Project 84201191

September 1, 2009

Re: Rosemont Copper Project
Responses to Dry Stack TSF Comments Provided by Dale Ortman

CLIENT	ROSEMONT COPPER				
PROJECT	ROSEMONT PROJECT				
TITLE	15-DAY PONDING COLUMN ANALYSIS MOISTURE CONTENT WITH DEPTH OVER TIME				
 EARTH AND ENVIRONMENTAL	DESIGNED BY	JLW	CHECKED BY	JWH	DATE
	DRAWN BY	JLW	APPROVED BY	JWH	09-01-09
FILENAME		FIGURE No.		REV	
FIGURE 1		1		A

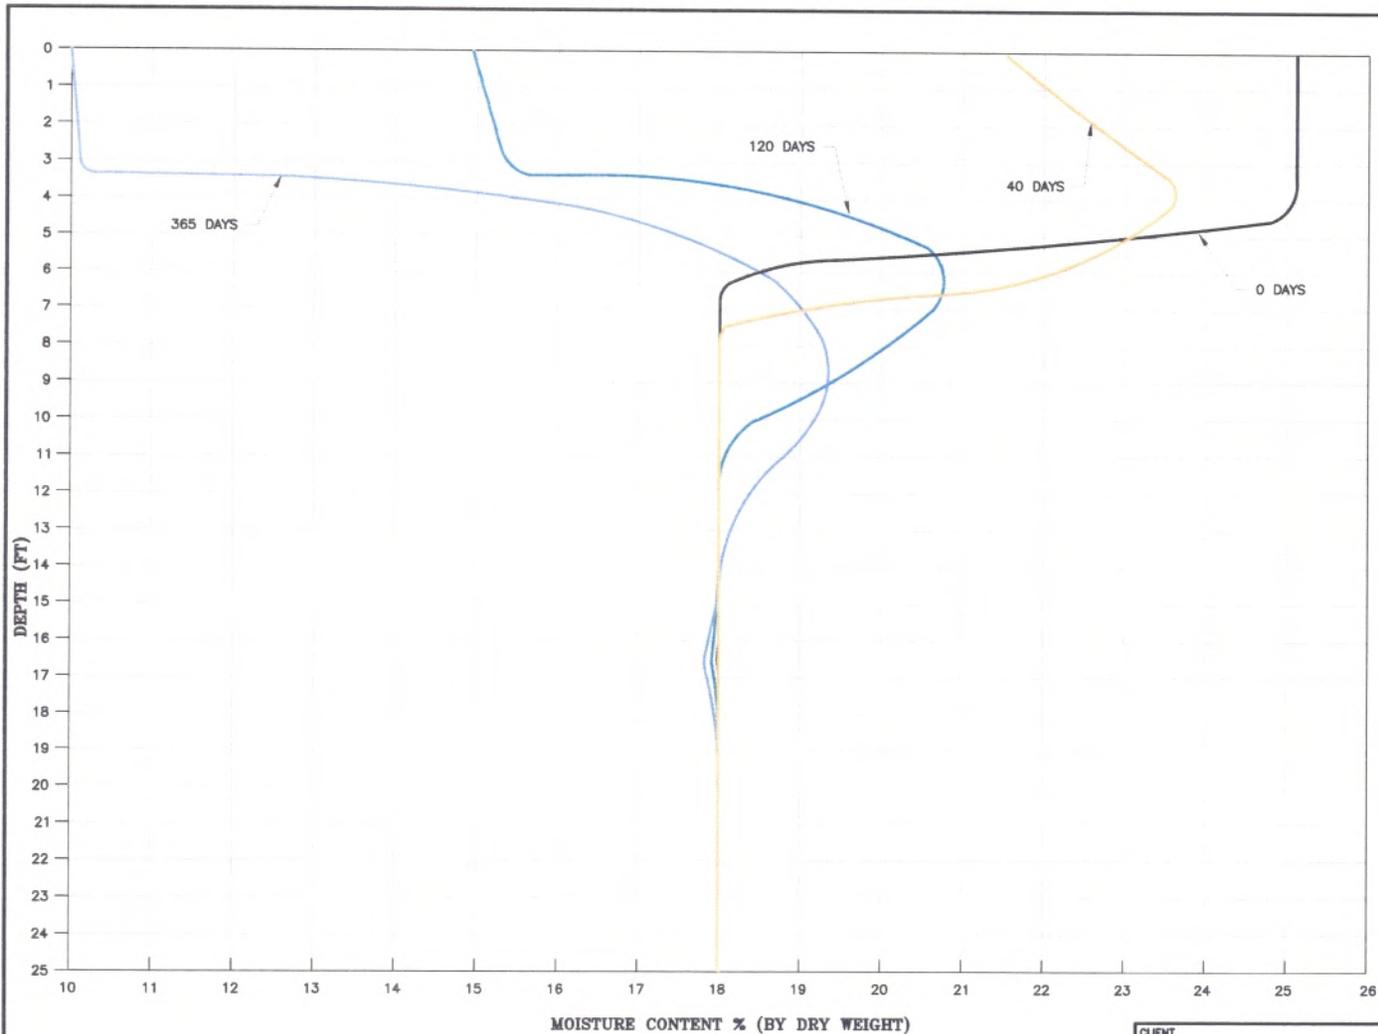
Comment 8: *The seepage analysis states that no ponding of storm water was included in the analytical boundary conditions. However, the design includes a top surface drainage grade of only 0.25% and construction using a radial stacker placing 25-foot lifts, and it is doubtful that both the construction method will allow grading control to maintain the 0.25% slope or the 0.25% slope will effectively drain the tailings top surface except during extreme flooding. Please provide additional rationale for the exclusion of ponding of storm water in the seepage analysis.*

In addition, a seepage analysis was completed as part of this response, in which water was ponded for a period 15 days on a column of soil represented by a constant head boundary condition. The 15 day time period represents the maximum amount of time for ponding water on the surface of the tailings. During this period, evaporation was not included and it was assumed that the top 15 feet of tailings were unconsolidated. After the wetting front due to the ponding of water was calculated, the column of soil was

then subjected to the average precipitation, evaporation, and temperature based on historic data obtained from the Santa Rita Experimental Range weather station for one year. As shown on Figure 1, the wetting front after 15 days is approximately 6.5 feet beneath the tailings surface. After 365 days, the water front only advances an additional 7.5 feet. It is important to note that after 1 year, the majority of water from the initial ponding has been consumed by evaporation, and only represents a minor component of Flux. Therefore, ponding water on the tailings surface for 15 days is not expected to have an appreciable effect on the overall seepage from the facility.
